Western States Petroleum Association
Credible Solutions • Responsive Service • Since 1907

May 22, 2015

Re: WSPA Comments on draft Regulation for Greenhouse Gas Emission Standards for Crude Oil and Natural Gas Operations – Second Round

Figure 5.2.1.1: Leak Rates vs. Screening Values of All Leaking Components

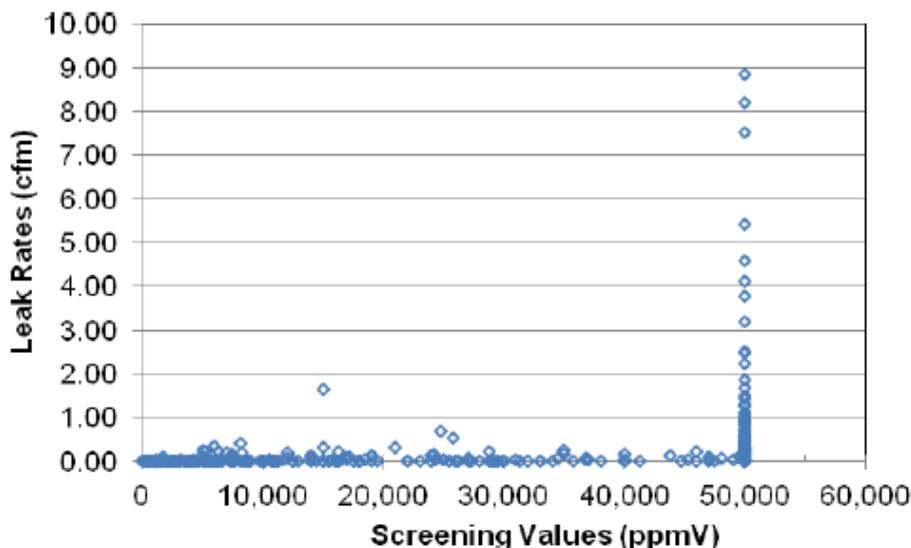
There is no technical basis for the assumption that a leak threshold below 10,000 ppm will result in significant emission reductions. In a study performed by California State University Fullerton (CSUF) under a California Energy Commission Project, it was clearly illustrated that there is no correlation between ppm determined through Method 21 and leak flow. Figure 5.2.1.1 of the

CSUF report provides a graph representing the concentration vs. leak rate data collected. The same data is separated into concentration ranges in Table 5.2.1.2. The Figure and Table are included below:

Using the CSUF data provided in Table 5.2.1.2, the total leak rate can be calculated. Using these total leak rates, the potential emission reduction can be calculated for each concentration threshold.

As seen in the table above, greater than a 90% reduction would result from the control of leaks above 50,000 ppm. If 10,000 ppm were to be selected as the threshold, greater than a 97% reduction would be realized. Conversely, a ppm threshold of 1,000 ppm would only result in less than 2.7% additional emissions capture beyond a 10,000 ppm cutoff and an additional drop to 500 ppm, as suggested by some stakeholders in ARB workshops, is effectively negligible.

As shown through these calculations, a ppm threshold below 10,000 ppm is not an effective method for emissions reduction nor is it cost effective due to the compliance costs associated with an LDAR program as discussed above. Therefore, most existing regulations consider 10,000 PPM as the threshold. Below is a table of comparison of existing regulatory leak thresholds:

In order to improve cost-effectiveness, minimize the burden on operators and align with existing major regulations, WSPA recommends that ARB define a leak at 10,000 PPM and a major leak at 50,000 PPM for facilities that are subject to existing local air district LDAR programs.

Figure 1. Typical high level steps involved in California's oil well completion activities with well stimulation treatments.

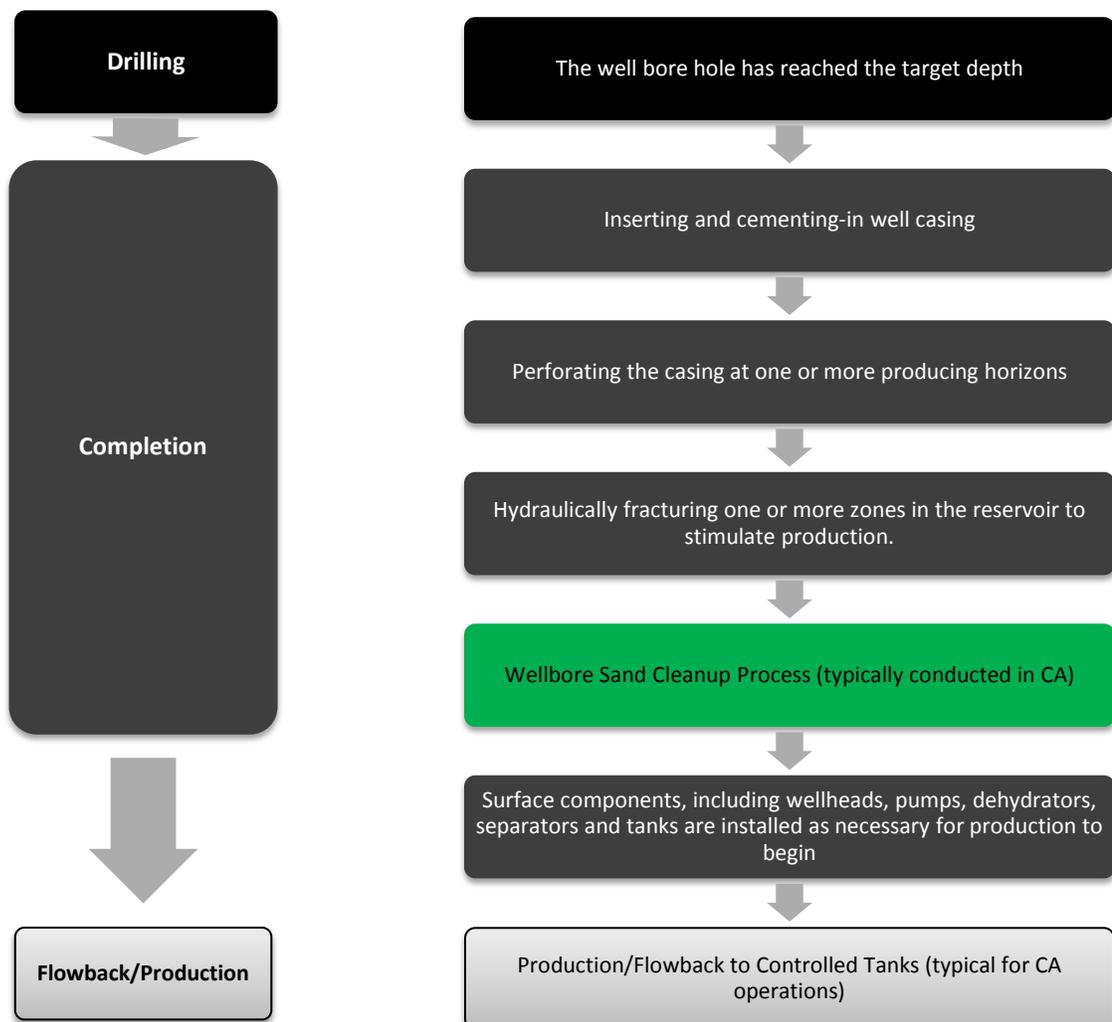
In order to accurately quantify the emissions from circulation tanks used in well stimulation treatments, it is critical to understand the processes in which the circulation tanks are used and differences from processes described in some other studies (e.g., [USEPA White Paper on Oil Well Completions](#)). During the Methane Rule Workshops held by ARB on April 27 and 29, 2015, several stakeholders were confused on ARB's intent to control circulation tanks and incorrectly assumed that ARB was trying to control emissions from flowback. WSPA is providing the description below to help clarify ARB's intent of controlling circulation tanks and associated emissions. A typical well stimulation treatment follows the steps described in Figure 1.

Typically, in non-California operations (as described in USEPA white paper for oil completions with hydraulic fracturing) the flowback¹ from the hydraulically fractured wells is directed to open tanks or pits. **However, California operators normally direct production flowback into the existing and permanent production tank systems that are typically required to have vapor recovery systems.** These systems, which the proposed regulation addresses separately, have overall capture and control efficiency rates ranging from 90% to 99.5%. The gas can be combined with fuel streams either for combustion, further gas processing, gas injection, or gas sales. Since these activities meet the definition of Reduced Emissions Completions (RECs) in the USEPA white paper, most California hydraulically fractured oil well completions are RECs or green completions.

California's oil fields generally produce very little gas (an average of 6 – 10 scf/bbl) due to low reservoir pressures, preventing the reservoir fluids from entering the wellbore without a lifting mechanism. As a result, operators have to conduct additional steps during oil well completions following well stimulation treatments (the wellbore sand cleanup process). This process is carried out separately prior to the flowback/production phase in order to clean out the sand from the wellbore. This separate process is unique to oil production fields where the reservoir pressures are very low and/or the gas to oil ratio (GOR) is very small. This is in contrast to fields with a higher GOR because the pressure in these wells will carry the sand out of the well without the need for the separate wellbore sand cleanup process.

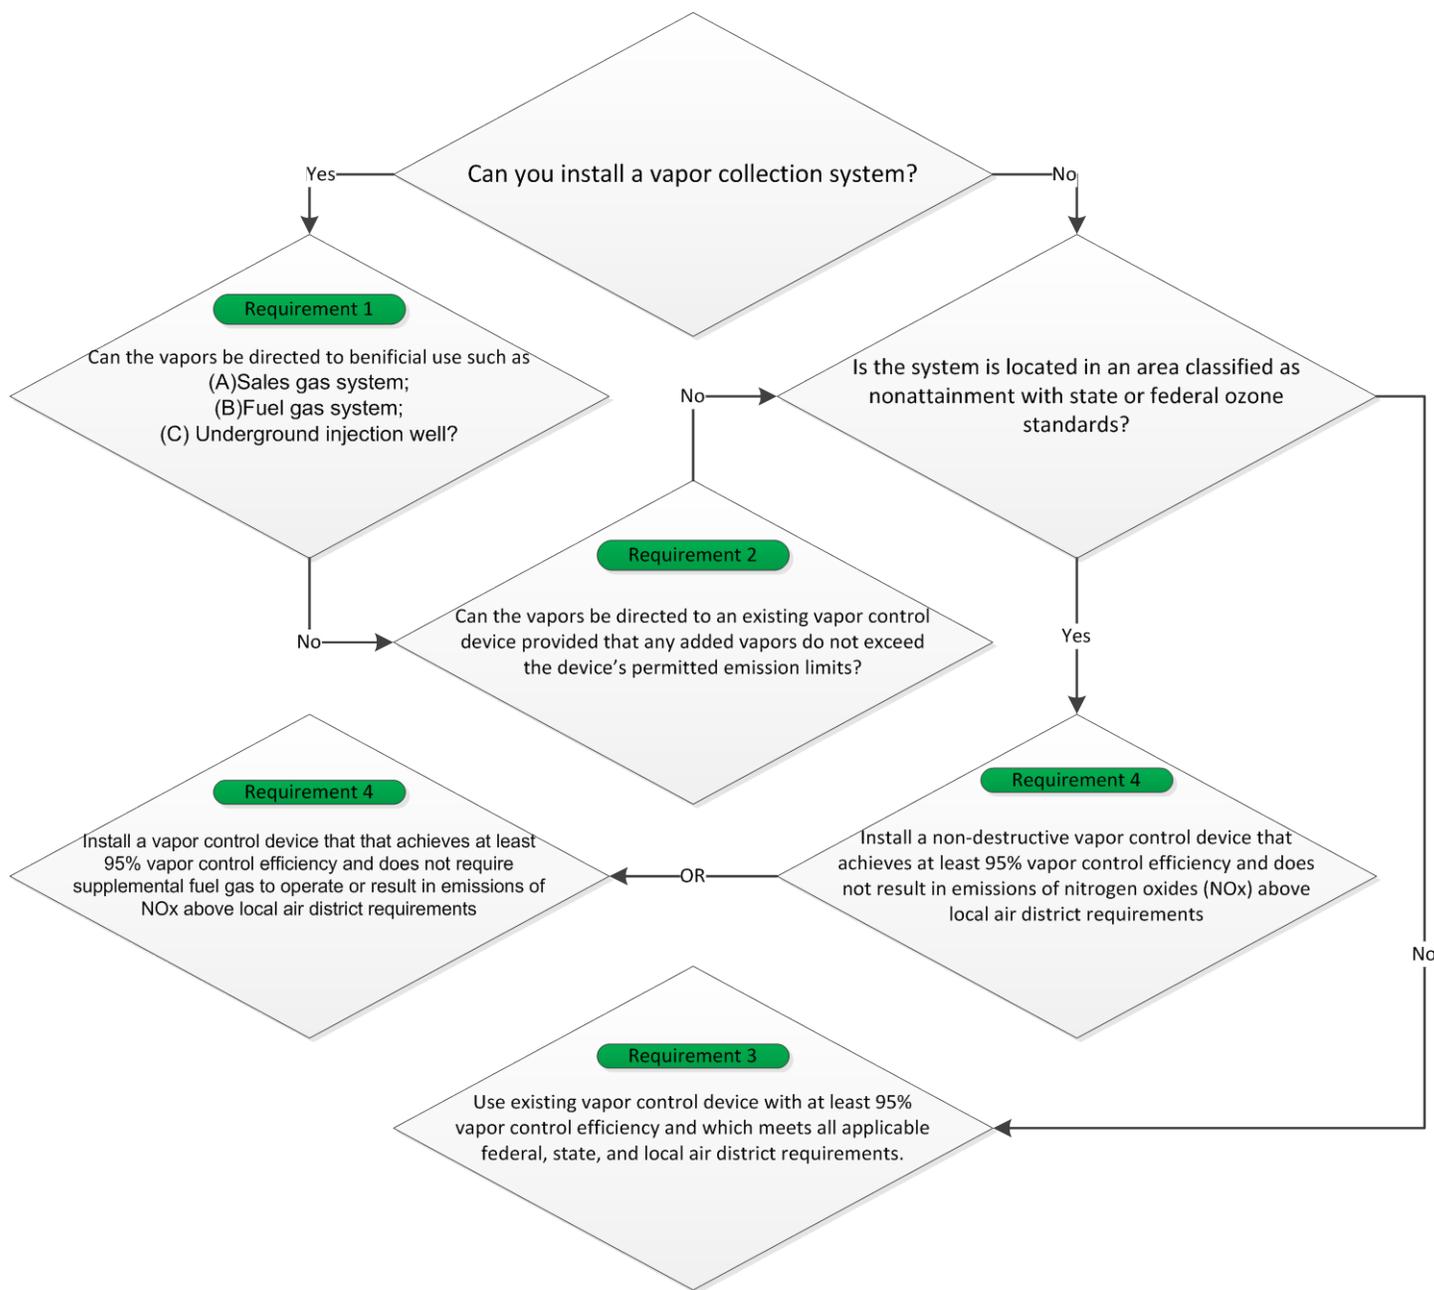
The proposed regulation identifies four control requirements for the temporary portable circulation tanks in the order of technical feasibility. These requirements are described in the following diagram.

As shown in the diagram, the requirements apply to all wellbore cleanup events regardless of the emissions from each event. WSPA is concerned about the technical feasibility of the proposed control technologies.

As discussed above, the wellbore sand cleanup process after a well stimulation event lasts for approximately 8-16 hours. There is not enough pressure from these tanks to allow the gas to be introduced into a vapor recovery system. This would require a compressor (an additional combustion source) to boost the pressure of the gas from the tanks high enough to allow it to enter a vapor recovery system. Connecting a temporary process with small amount of gas to an

There is no proven existing technology that can capture the small amount of gas/vapors from these events and control with a demonstrated efficiency of 95%. Technologies provided by the two vendors (who were consulted) have been used only for flowback and production processes where the amount of gas is significantly higher than the wellbore sand cleanup process. The two vendors have clearly stated that their technologies have not been tested or used in the wellbore sand cleanup process.

None of the control technologies proposed above can be technologically achievable for most of the events taking place in California. The current proposed regulation has not considered the possibility of not being able to implement the options of control listed in Section 95213(c), especially where the gas volumes are low and fluctuating. As noted above, there are no existing control technologies that are proven to provide 95% capture and control of emissions from circulation tanks. The proposed “new” systems from vendors are yet to be tested or used in wellbore sand cleanup process and there are no guarantees that those systems will achieve the proposed capture and control requirements.

Alternative Methods of Control: As the current proposed regulation has not considered the possibility of not being able to implement the options of control listed in Section 95213(c), WSPA suggests that ARB consider adding to the regulatory language an alternative method of controlling emissions for events that are below 10 MT CH₄ and those events where none of the proposed control technologies would be feasible. WSPA is suggesting the development and implementation of a Best Practices Management Plan (BMP) as an alternative method of control. Some of the best practices that can be implemented including but not limited to:

Example 1

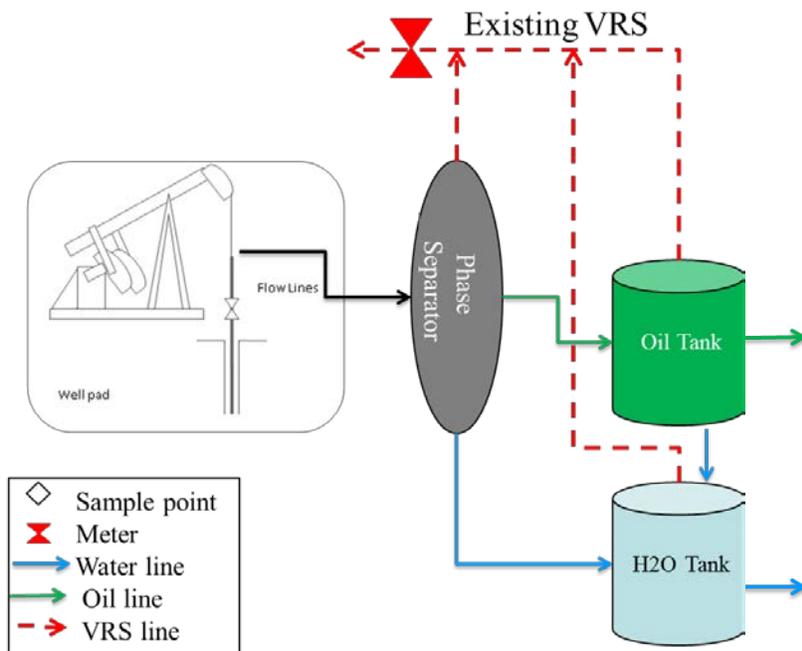
WSPA understands that Example 1 configuration would not be subject to any of the proposed requirements in the regulation since the first vessel (Phase Separator) and the second vessels (Oil and Water tanks) following a well on the crude oil and produced water lines are already under vapor recovery.

WSPA requests that ARB clarify the scope of the regulation as suggested below in the Recommendation section. If ARB's intent is different from WSPA's understanding, WSPA would like ARB to provide further clarifications.

Example 2

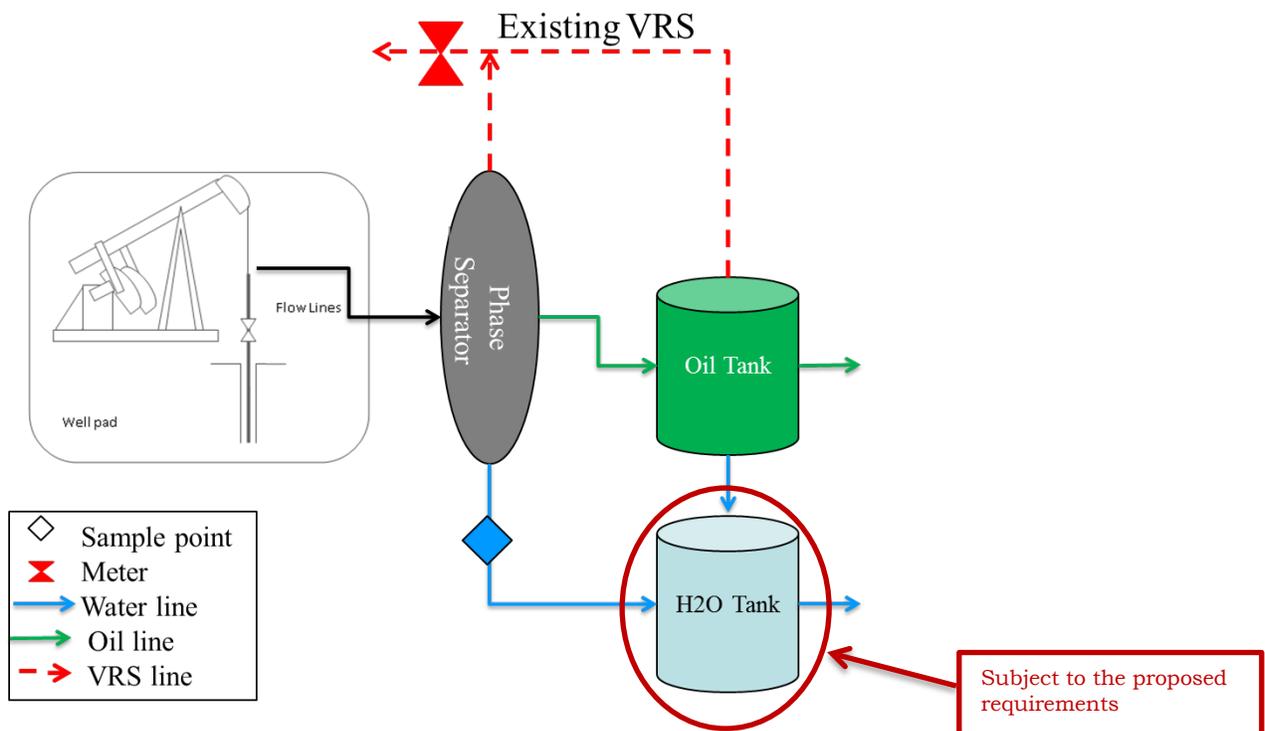
WSPA understands that in the Example 2 configuration shown below, only the identified produced water tank would be subject to the proposed requirements of the regulation.

Example 3

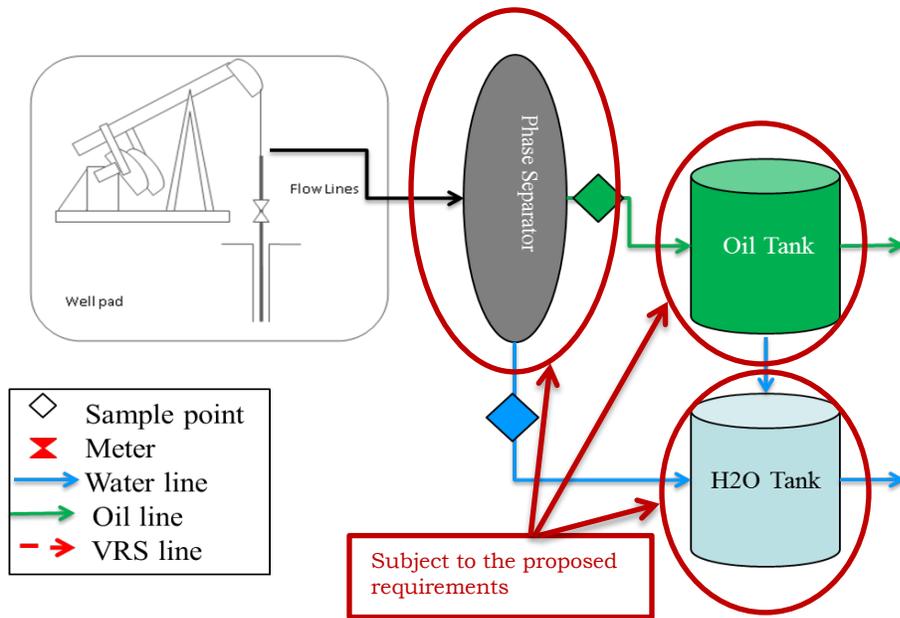
WSPA understands that in the Example 3 configuration shown below, the identified phase separator, oil tank, and produced water tank would be subject to the proposed requirements of the regulation.

Example 4

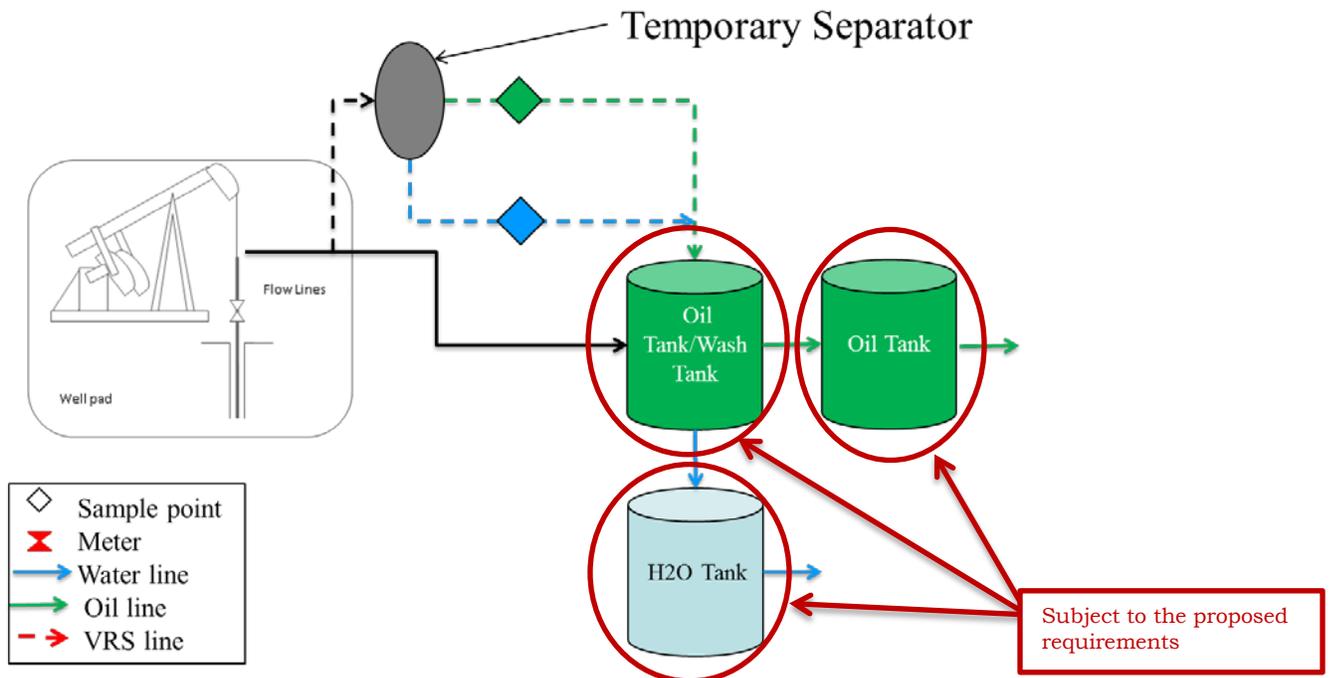
WSPA understands that in the Example 4 configuration shown below, the identified oil tanks and produced water tanks would be subject to the proposed requirements of the regulation.
